AUTHORS' RESPONSE TO REFEREE No. 1 (Paola Salvati)

AUTHORS' RESPONSE TO REFEREE No. 2 (E. Poyiadji)

Certificate of translation of the paper “Landslide risk management analysis on expansive residential areas. Case study of La Marina (Alicante, Spain)” (ES>EN)

Fig. 2 Curve trend of different types of Risk Ratio

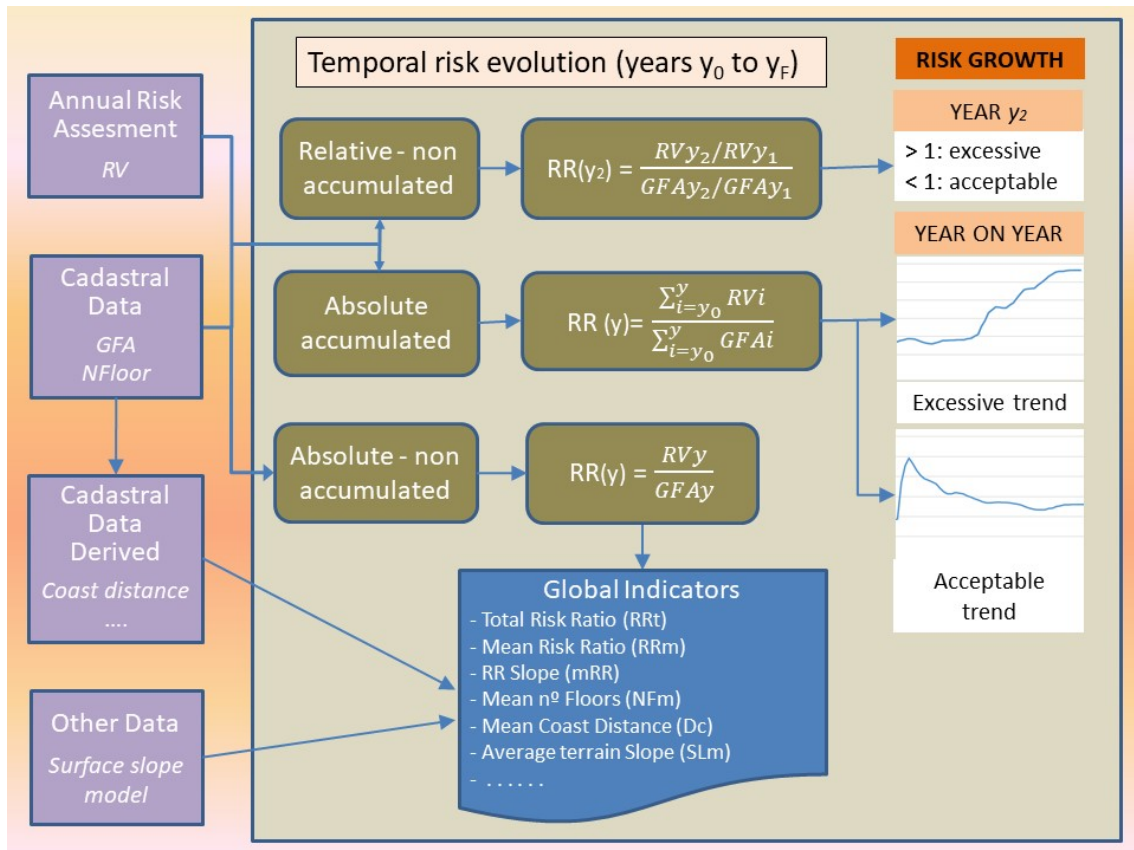
7.1. Section 2, “General Methodology” needs a graphical schema to illustrate the different theoretical issues.

Given that the section “Temporal Evolution of Risk” is one of the most relevant ones in the paper, new paragraphs have been added to the article following the reviewer’s suggestion. Furthermore, a new diagram has been added (Temporal risk flow chart, Fig. 2) showing the method explained in the section. The updated text is given below, as well as the new figure.

Fig 4. La Marina area. Susceptibility, landslides location and areas with instabilities

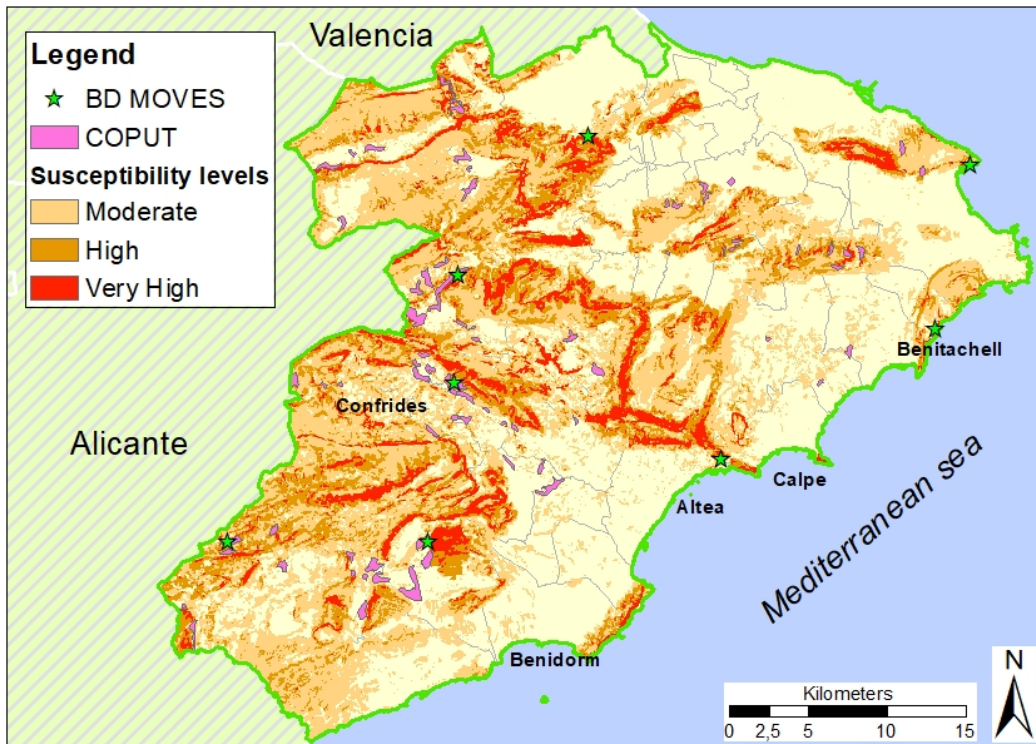
7.4. Section 3, "Case study". It should be better to highlight that you are assessing the specific risk. You are assessing the risk in terms of expected economic loss due to landslide damage to residential building and not the total risk. In my opinion there are some basic data that you missed.

Following the reviewer's advice, a new map has been created in Figure 4 attached, indicating the three highest levels of susceptibility, together with the location of landslides according to the Spanish Geological Survey (BD-MOVES) and the areas with instabilities according to the Valencia Regional Government (COPUT).

Fig. 2 Curve trend of different types of Risk Ratio

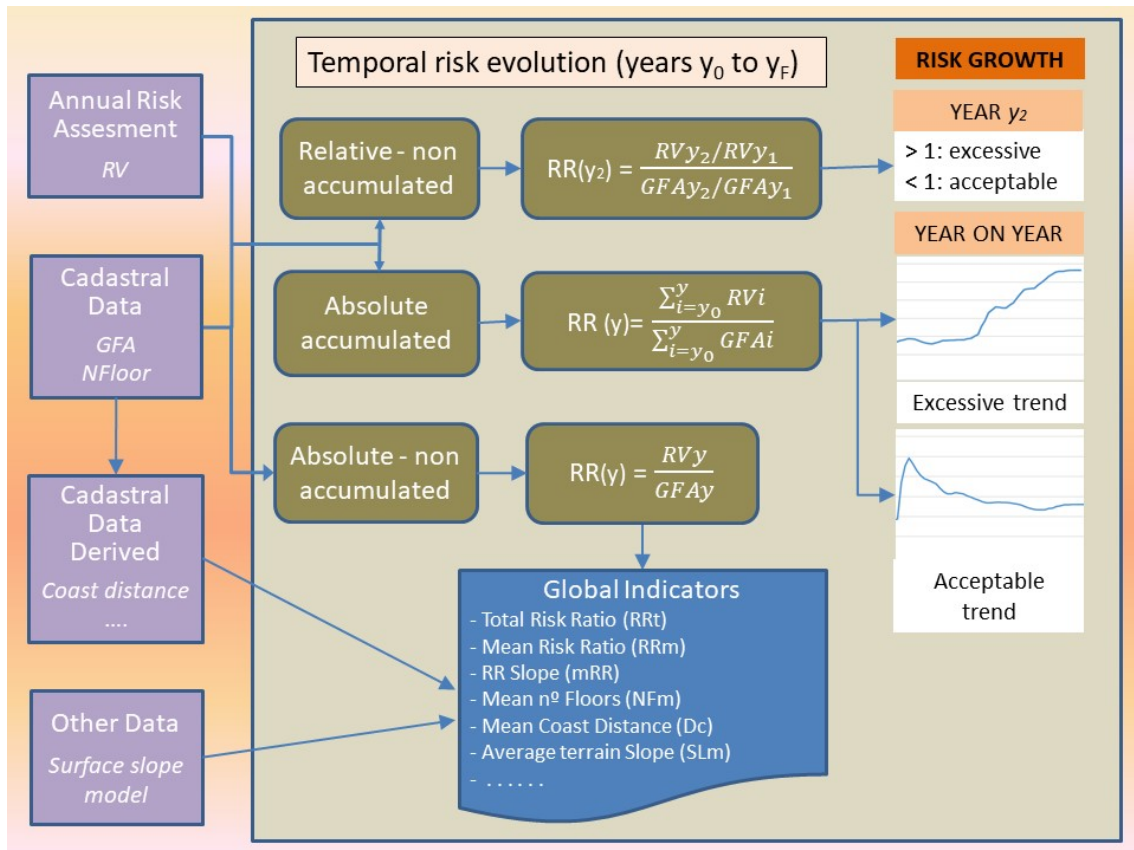
3. Moreover, the authors believe that following the proposed methodology would be able to determine what causes the incidence of landslide risk (geomorphology, chance, land management, etc.), and would finally be able to suggest control tools for the public bodies tasked with monitoring such matters. In my opinion the methodology described has many unclear points and many gaps.

Given that the section “Temporal Evolution of Risk” is one of the most relevant ones in the paper, new paragraphs have been added to the article following the reviewer’s suggestion. Furthermore, a new diagram has been added (Temporal risk flow chart, Fig. 2) showing the method explained in the section. The updated text is given below, as well as the new figure.
